Objection to Confirmation  
Of A6 to Manchester Airport A55 Side Roads Order  
Reference OBJ/25/01

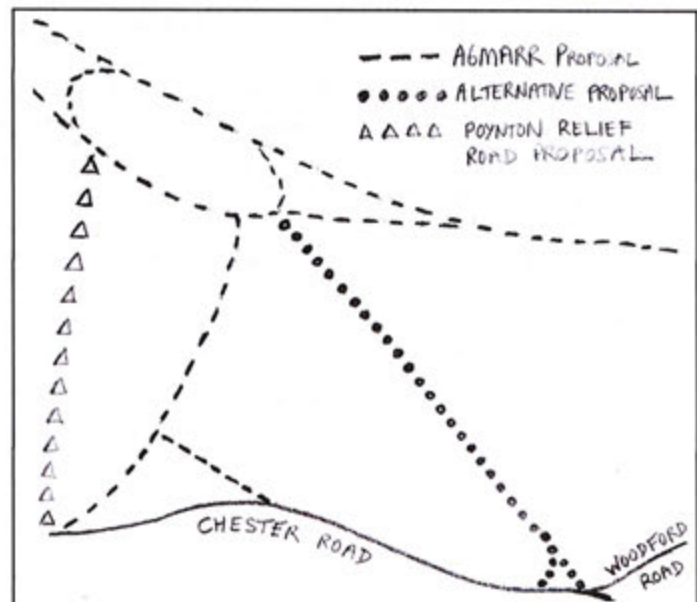
a) My proposal (see embedded sketch) should reduce the number of accidents at the intersection of Woodford Road and Chester Road which surely should be an aim of the A6MARR Proposal. As there is already decelerating and accelerating traffic noise and standing traffic air pollution at this junction, my proposal would be to make it a traffic light junction and run the access road to the A6MARR from this traffic light junction rather than have a new junction and link with Chester Road a few hundred yards up the road westwards towards Woodford.

If my proposal was adopted, for traffic wishing to join the A6MARR, it would take westbound traffic off Chester Road sooner reducing noise and air pollution to a number of properties. Only a limited amount of traffic wanting to join the A6MARR should travel eastbound along Chester Road as only a few households down from the proposed junction it would be quicker for them to travel westwards and join at the Bramhall junction.

It should be noted that my proposed junction has potential to be high capacity as: -

- i) there is already a right hand turn lane for Woodford Road for traffic travelling west along Chester Road
- ii) there is room to introduce 2 lanes at the end of Woodford Road & also Chester Road travelling east wards before you get to Woodford Road
- iii) the link road can also have 2 or more lanes approaching the junction

If my proposal is adopted, the amount of land to be purchased as a result of the scheme should be no more than the Proposal and could be less because some or all of i) and ii) above can be achieved on land already owned by the Councils and because there should be scope to use some of the existing footprint of the existing access road to the Oil Terminal. A possible fringe benefit could be the use of a drainage ditch proximate to the north east of my proposed route.

**b)** My proposal should also improve the general flow of traffic, compared with the A6MARR Proposal, by not introducing a new junction a few hundred yards westwards up Chester Road towards Woodford. Under the A6MARR Proposal, at busy times of day, it is easy to predict that the traffic will build up eastwards on Chester Road from the link road traffic lights all the way back to the junction with the Woodford Road, making it very difficult to get out of Woodford Road on to Chester Road.

At the meeting the Council view was that the new junction as currently planned provides a higher capacity junction than could be provided at a junction between Woodford Road and Chester Road.
